# FLOOD CONTROL DISTRICT OF MARICOPA COUNTY

APPEAL  
to  
Scottsdale Alluvial  
"Fans 5 & 6"  
February 26, 1992

APPEAL TO PRELIMINARY FIRMS FOR  
FEMA DESIGNATED FANS 1-6  
NORTH SCOTTSDALE FLOOD INSURANCE STUDY

Subject: Appeal of Flood Elevation Determination

Figure 1 - from Physical Geology by Foster

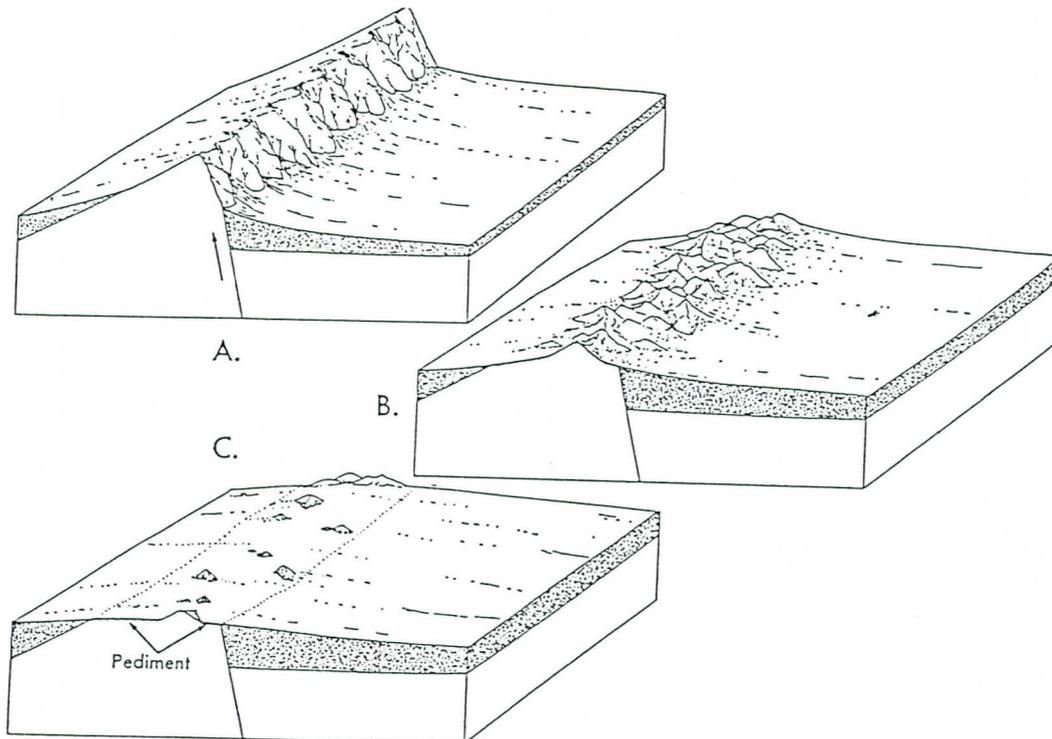
2. Appeal Basis: Per the following technical reports, FEMA letter and Figure 1, the subject site is not an active alluvial fan. "Soils in this area have substantial clay and calcium carbonate content. These properties provide cohesion to the soils; thereby, making them resistant to erosion. Many of the streams in this area exhibit thick accumulations of calcium carbonate (caliche) on their beds and banks, which further add to channel stability. These properties are not characteristic of active alluvial fans." (From [b] below).

- a. the assumption that this study area is an active alluvial fan be dismissed;
  - b. the application usage of the alluvial fan model to Washes 5 & 6 be dismissed;

- c. the preliminary FEMA floodplain delineations be dismissed for Washes 5 & 6 as invalid; and,
  - d. the "wash corridor" floodplains (delineated as non-alluvial fan, Zone A) as prepared by the local agencies be adopted by FEMA

Figure 5-8. Alluvial Fan Boundaries

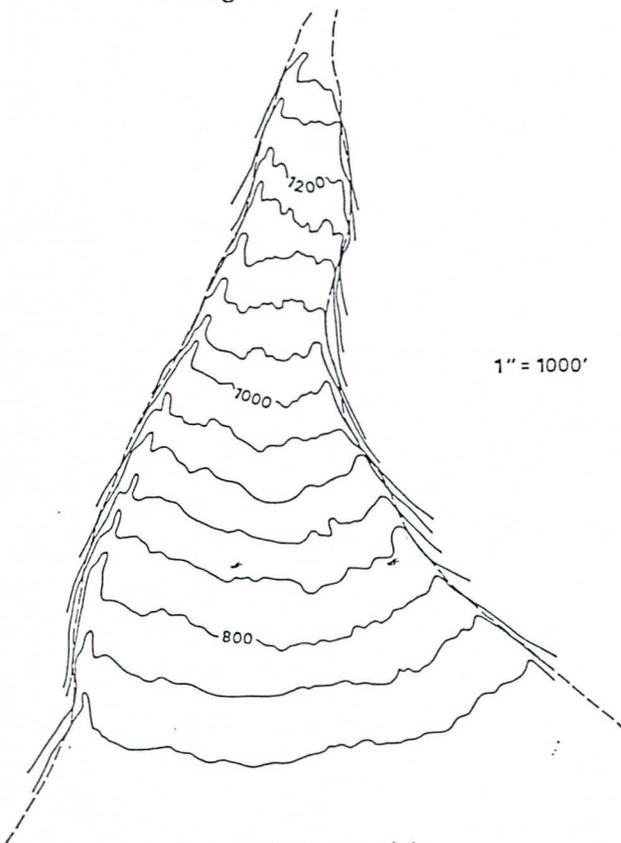
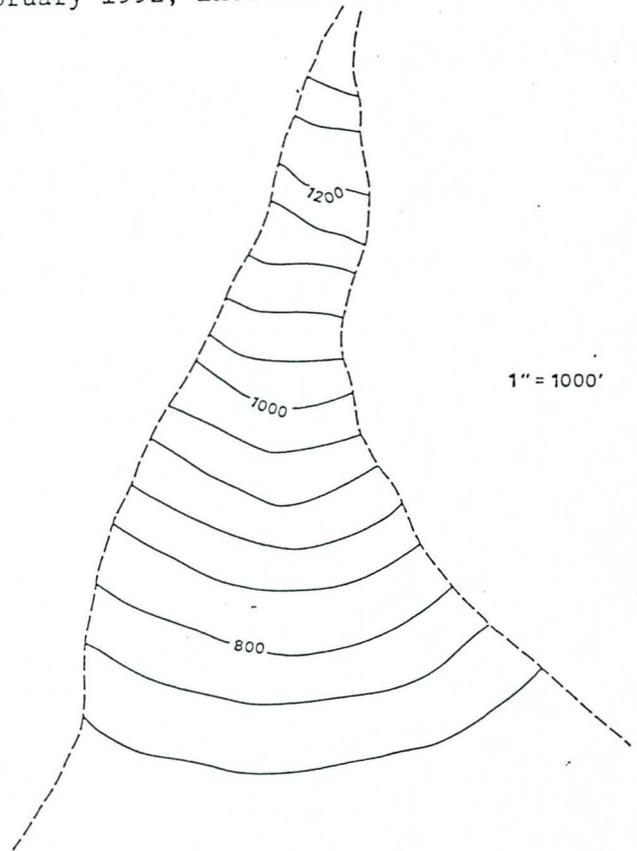
13. Appeal Basis: The FEMA methodology assumes a constant energy depth across a contour delineating flood depths and does not measure elevations from the thalweg of the wash ignoring the topographic relief across a DFA. Based upon this procedure which ignores topographic relief and thalweg elevations, the use of the avulsion coefficient is inappropriate in that there is no wash from which the runoff is to avulse. In addition, the assessment of flooding hazards must be based upon channel conveyance and existing topographic relief, versus a probabilistic model that has no site specific ground truth and generates erroneous depths and velocities when measured from ground elevations or the invert of the wash, thus giving a false sense of security and underestimating flood hazards.

- a. the preliminary FEMA floodplain delineations be dismissed as invalid; and,
- b. the "wash corridor" floodplains (delineated as non-alluvial fan, Zone A) as prepared by the local agencies be adopted by FEMA, Enclosure 33.

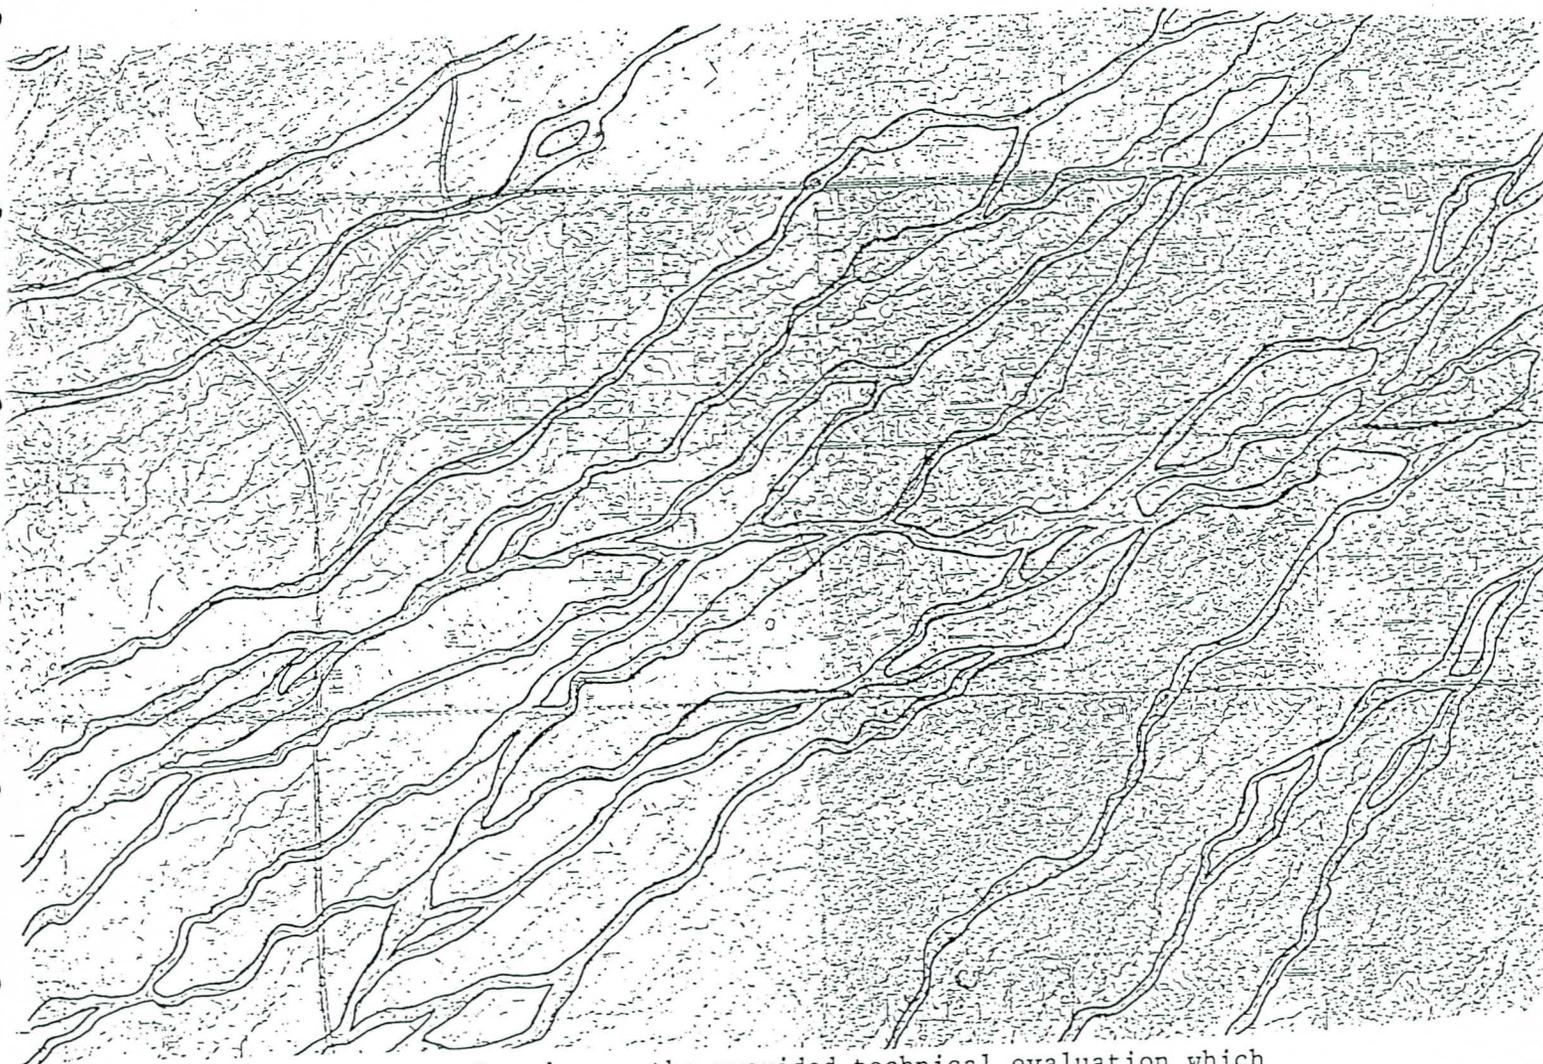
14. Appeal Basis: The FEMA methodology assumes a constant energy depth across a contour for modeling and delineating flood depths. A comparison of the FIS to existing topography indicates that runoff would be primarily conveyed in major corridors which have more frequent and greater depths of flooding than those drainage swales collecting only local runoff or sheetflow. The flood hazard in these areas would be greater than the generalized A01 depth which does not recognize this hazard.

- a. the preliminary FEMA floodplain delineations be dismissed as invalid; and,
- b. the "wash corridor" floodplains (delineated as non-alluvial fan, Zone A) as prepared by the local agencies be adopted by FEMA.

### VELOCITY-DEPTH RELATION: PREDICTED AND RECONSTRUCTED

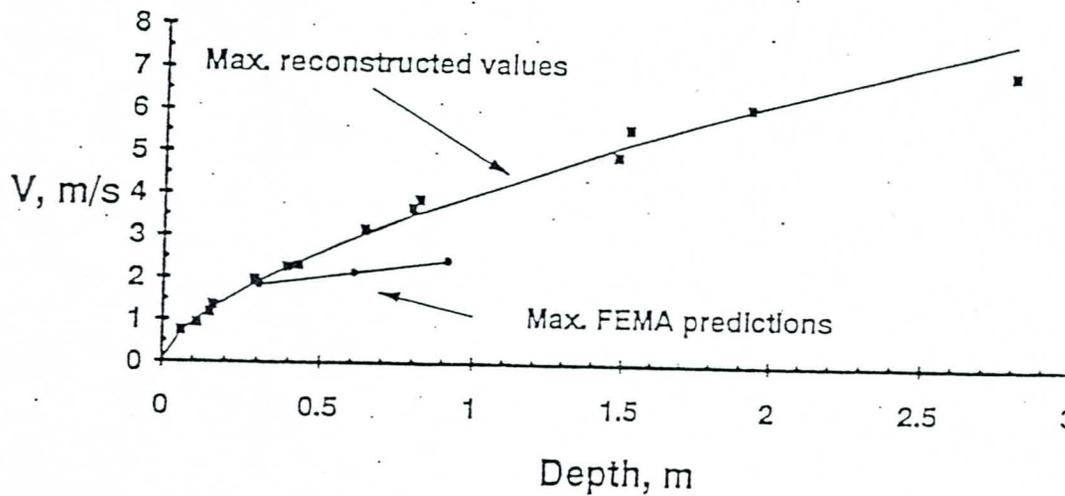
27. Appeal Basis: Hydraulics developed by FEMA methodology do not realistically reflect true velocities or depths, nor is it based upon channel conveyance indicative of the existing topography.
- (CVL), Geomorphologic Description & Hydraulic Analysis for FEMA Designated Washes 5, 6A, 6B, & 6C, February 1992, Enclosure 10
  - Hydraulics by FCD

This graph depicts the velocity-depth trend of maximum values obtained from the hydraulic modelling of 14 individual reaches conveying floodwaters during the 1988 Wild Burro flood. The individual points represent the maximum depth and channel velocity for individual cross-sections in each reach. Also shown is the entire range of the maximum velocity and depth values predicted by the FEMA model.

- the application of the alluvial fan model to Washes 5 & 6 be dismissed;
- the preliminary FEMA floodplain delineations be dismissed as invalid; and,
- the "wash corridor" floodplains (delineated as non-alluvial fan, Zone A) as prepared by the local agencies be adopted by FEMA.

Figure 5-8. Alluvial Fan Boundaries

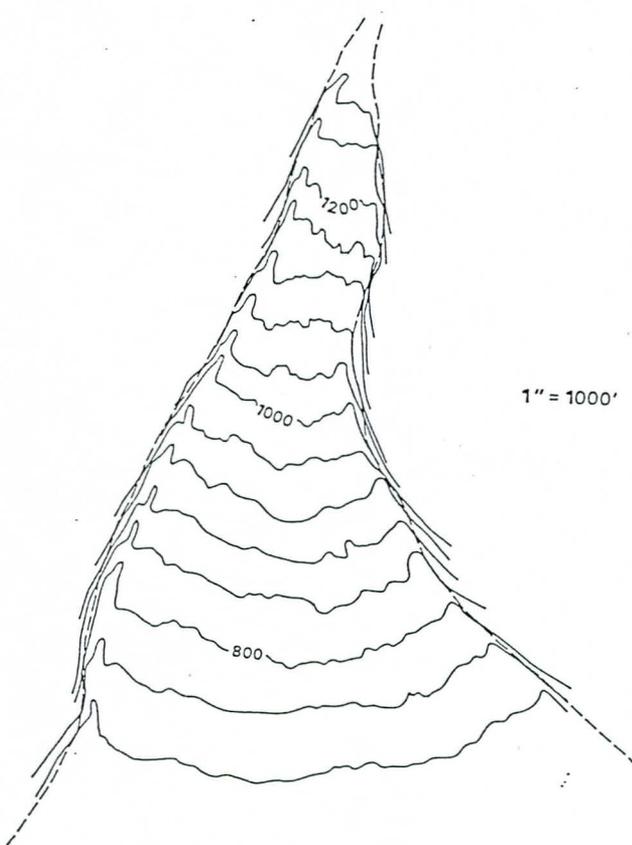
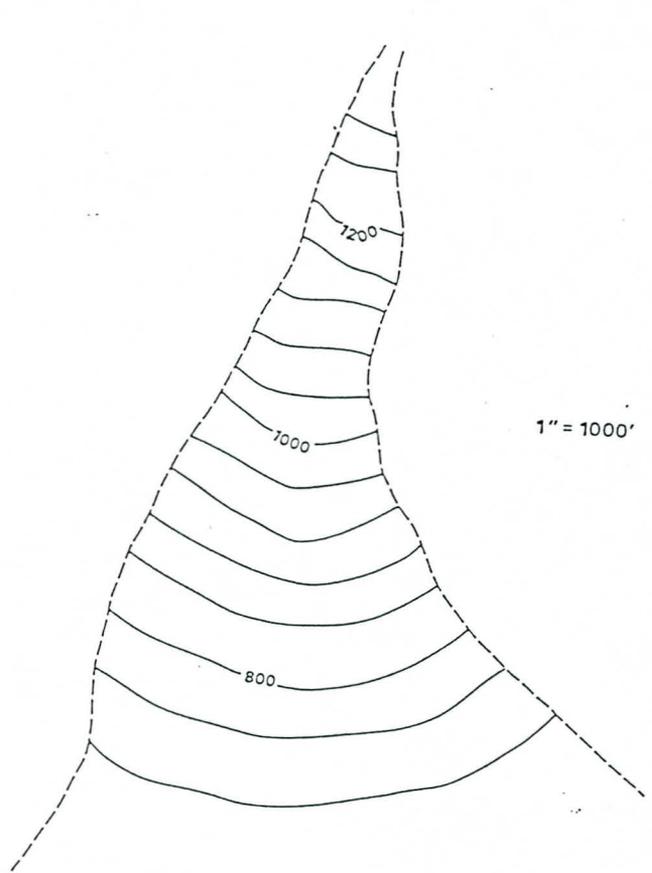
30. Appeal Basis: The flow patterns of Washes 5 & 6 are not characteristic of alluvial fans which have a distinct feature, whereby the slopes in all directions from the apex are approximately the same as defined in the DMA Report.

- a. the application of the alluvial fan model on this watershed be dismissed;
- b. the preliminary FEMA floodplain delineations be dismissed as invalid; and,
- c. the "wash corridor" floodplains (delineated as non-alluvial fan, Zone A) as prepared by the local agencies be adopted by FEMA.
